# SERVICE BULLETIN

TITLE Ash Tray Cover

BULLETIN NO. 246

MODELS AFFECTED: 108 (Voyager) Serial 108-1 through  
108-2412

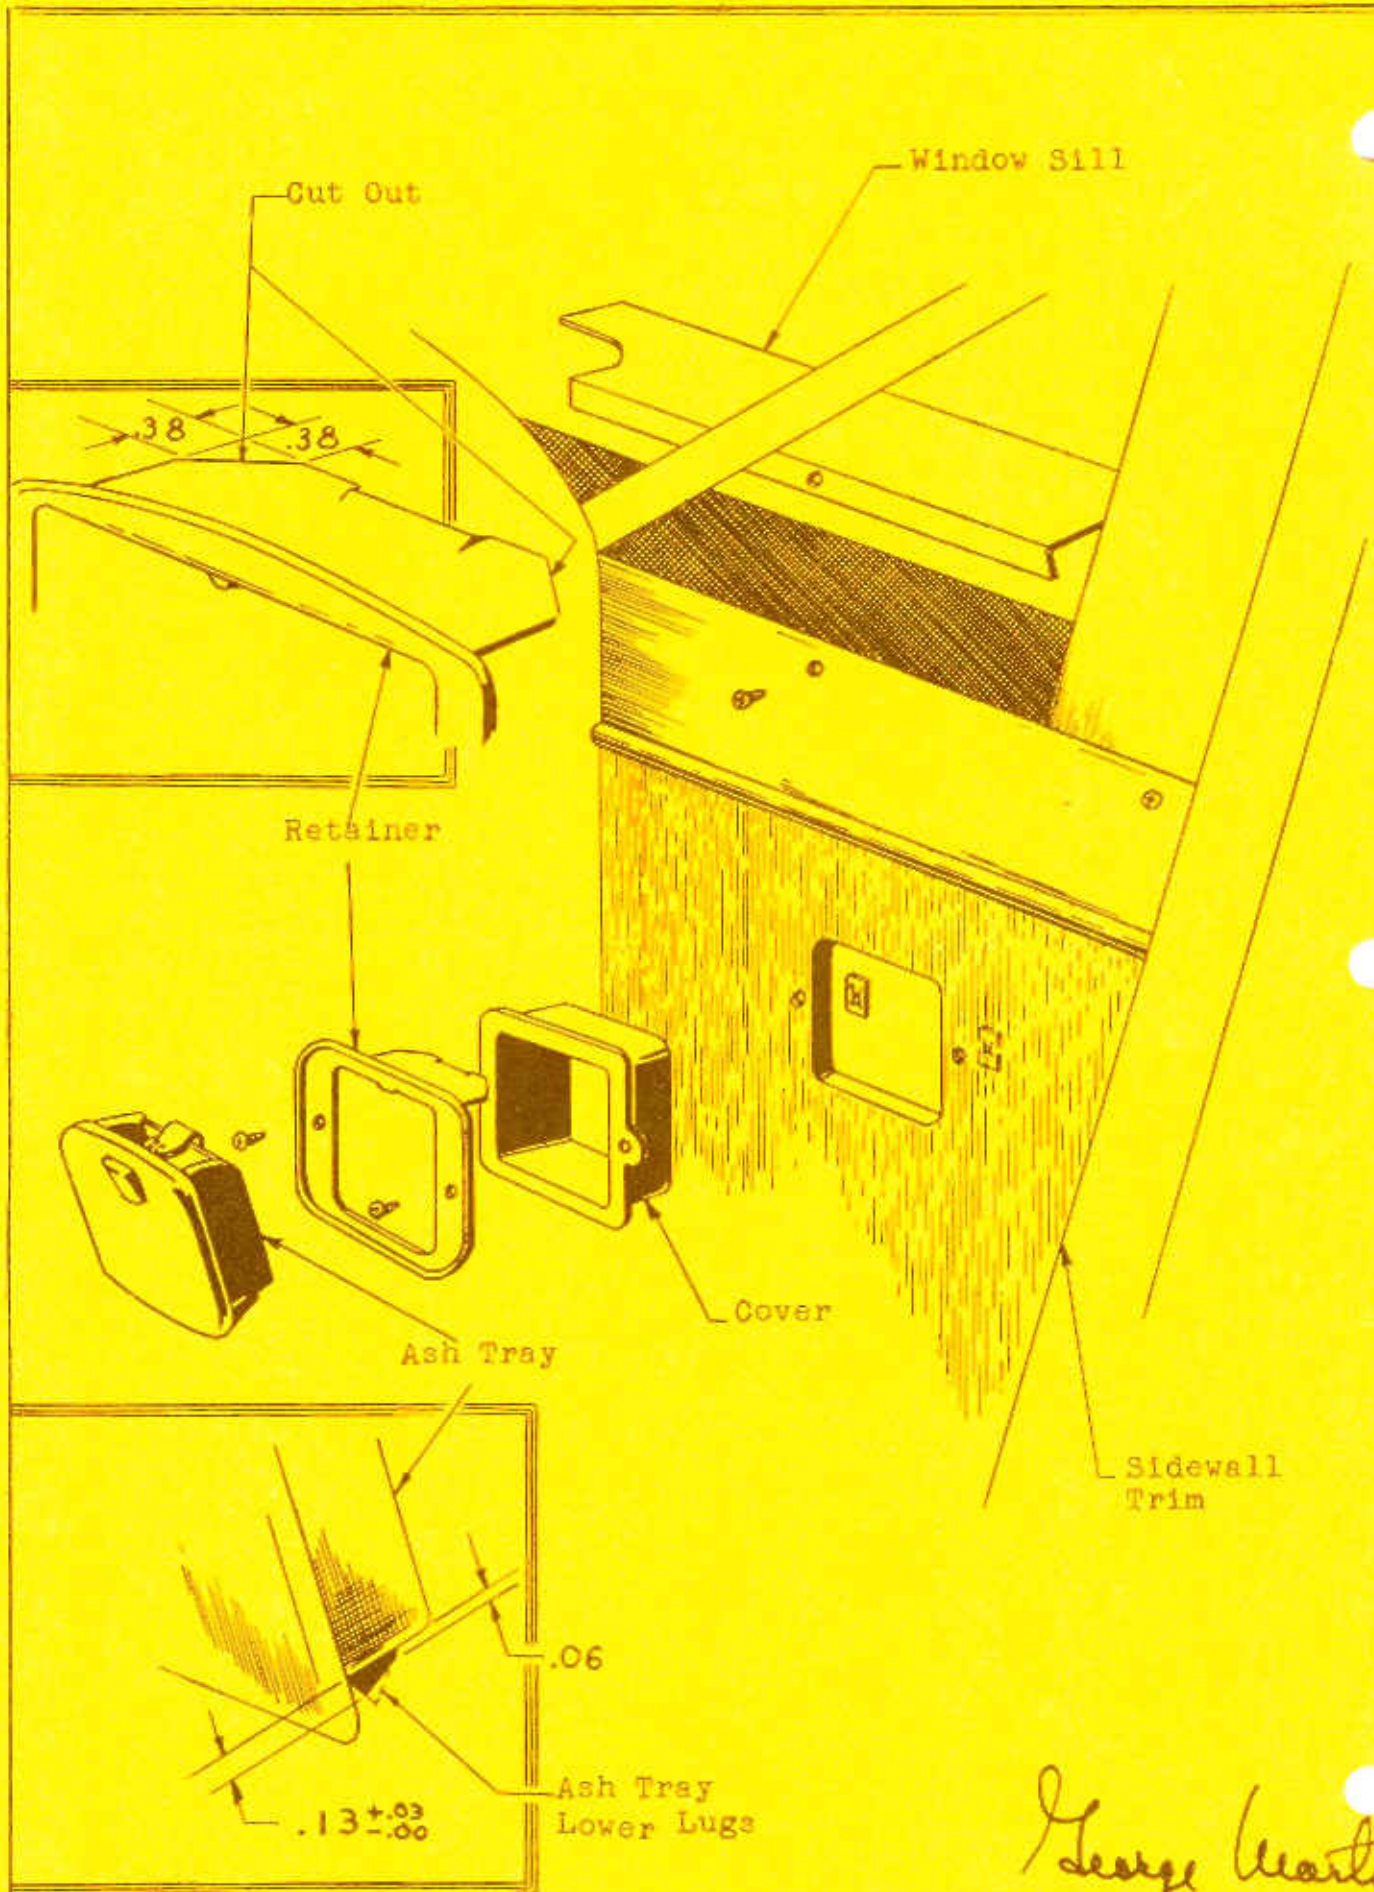
1. Remove ash tray and retainer attached to the sidewall trim.
2. Enlarge hole in trim sufficiently to accommodate cover.
3. Remove window sill at top of trim panel to permit access to Tinnerman nuts when reassembling ash tray retainer and cover to sidewall trim.
4. Modify retainer as shown on figure 1 so that retainer will seat in cover.
5. Insert cover and ash tray retainer, and secure to sidewall trim with new screws and Tinnerman nuts in the manner of the original installation. The nuts must be inserted from above using long nosed pliers.
6. Reinstall window sill.
7. Modify ash tray lower lugs as shown on figure 1 so that ash tray will fit in retainer, and insert ash tray.
